STAFF REPORT
COMMUNITY DEVELOPMENT DEPARTMENT

HEARING DATE: 8/22/2023
TO: Mayor & City Council
FROM: Sonya Allen, Associate Planner
208-884-5533
SUBJECT: Sessions Parkway - MDA
[H-2023-0030](#)
LOCATION: 2700 N. Eagle Rd., in the NW 1/4 of
Section 4. T.3N., R.1E. (Parcel
#S1104233650)

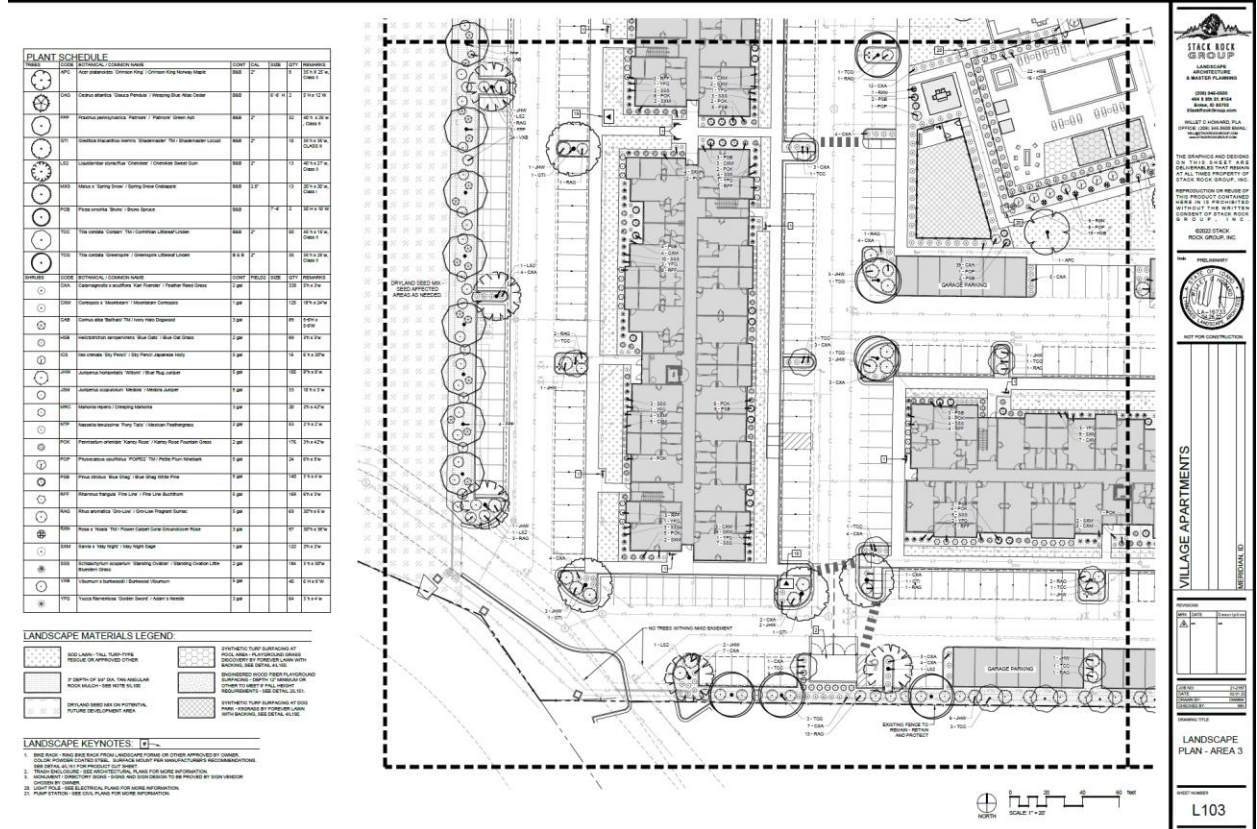
~~#5.1a.iii – If the site develops consistent with concept plan option 2, the applicant shall construct a minimum 5-foot 4-foot wide sidewalk on along the east side of the north/south drive aisle boundary through the site (instead of along the east boundary of the site as shown on concept plan) and provide a decorative crosswalks across the where pedestrian walkways cross internal drive aisles. Pedestrian walkways shall be provided at the east boundary of the site to of the multi-family portion of the development (NWC and SWC of the Village Apartments) to enhance pedestrian connectivity.~~
